RESUBDIVISION OF GULF FEDERAL CREDIT UNION **COMMERCIAL SUBDIVISION**

APPLICATION NUMBER 4 DATE June 6, 2013

REQUEST Subdivision

DETAIL SITE PLAN

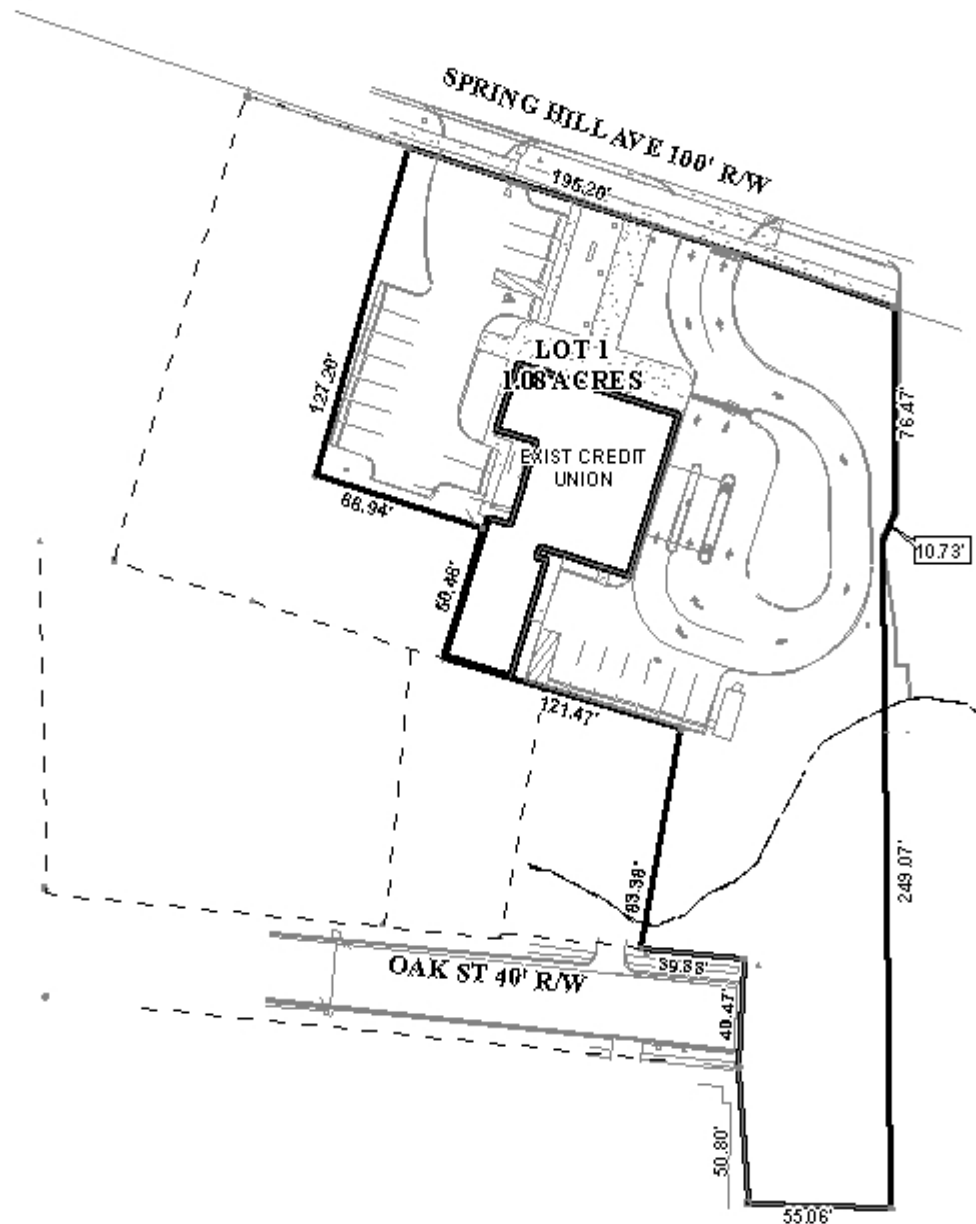
Engineering Comments: The following comments should be addressed prior to review, acceptance and signature by the City Engineer: 1. Provide all of the required information on the Final Plat (i.e. signature blocks, signatures, certification statements, legal description, required notes). 2. Provide a signature block and signature from the Traffic Engineering Department. 3. Add a note to the Plat stating that storm water detention will be required for any future addition(s) and/or land disturbing activity in accordance with the Storm Water Management and Flood Control Ordinance (Mobile City Code, Chapter 17, Ordinance #65-007 & #65-045). 4. Show/label the MFFE on Lot 1.

Currently, the proposed lot is developed with one curb cut to Oak Street and two curb cuts to Springhill Avenue. Because Springhill Avenue is a major street and a State Highway, access management is a concern. As such, the lot should be limited to the existing two curb cuts, with the size, design, and exact location of the curb cut to be approved by Traffic Engineering and ALDOT, and conform to AASHTO standards.

Section V.D.9. of the Subdivision Regulations regarding the 25-foot front setback can be waived due to the fact the lot is zoned B-4, however, a note should be placed on the Final Plat that if the lot is ever rezoned to a classification other than B-4, General Business District, then the required front yard for that zoning district shall be the required front yard.

The southern portion of the site is located within the flood zone. It appears to be partially located in the "500-year" frequency flood zone as depicted on FEMA maps, and thus may be subject to flooding. The presence of wetlands and floodplains indicate that the area may be environmentally sensitive; therefore, the approval of all applicable federal, state and local agencies would be required prior to the issuance of any permits or land disturbance activities.

With a waiver of Section V.B.14. of the Subdivision Regulations regarding right-of-way widths for Oak Street and Section V.D.9. of the Subdivision Regulations regarding the 25-foot front setback, the Subdivision request is recommended for tentative approval for one lot subject to the following conditions:

- 1) placement of a note on the Final Plat stating that the lot is limited to the two existing curb cuts to Springhill Avenue and one curb cut to Oak Street, with the size, design, and exact location of the curb cut to be approved by Traffic Engineering and ALDOT and conform to AASHTO standards;

- 2) placement of a note on the Final Plat stating that if the lot is ever rezoned to a classification other than B-4, General Business District, then the required front yard for that zoning district shall be the required front yard;

- 3) compliance with Engineering comments: (*The following comments should be addressed prior to review, acceptance and signature by the City Engineer: 1. Provide all of the required information on the Final Plat (i.e. signature blocks, signatures, certification statements, legal description, required notes). 2. Provide a signature block and signature from the Traffic Engineering Department. 3. Add a note to the Plat stating that storm*

water detention will be required for any future addition(s) and/or land disturbing activity in accordance with the Storm Water Management and Flood Control Ordinance (Mobile City Code, Chapter 17, Ordinance #65-007 & #65-045). 4. Show/label the MFFE on Lot 1);

- 4) placement of a note on the plat stating that approval of all applicable Federal, state and local agencies is required for flooding issues, if any, prior to the issuance of any permits or land disturbance activities; and
- 5) placement of a note on the final plat stating that development of the site must be undertaken in compliance with all local, state and Federal regulations regarding endangered, threatened or otherwise protected species.
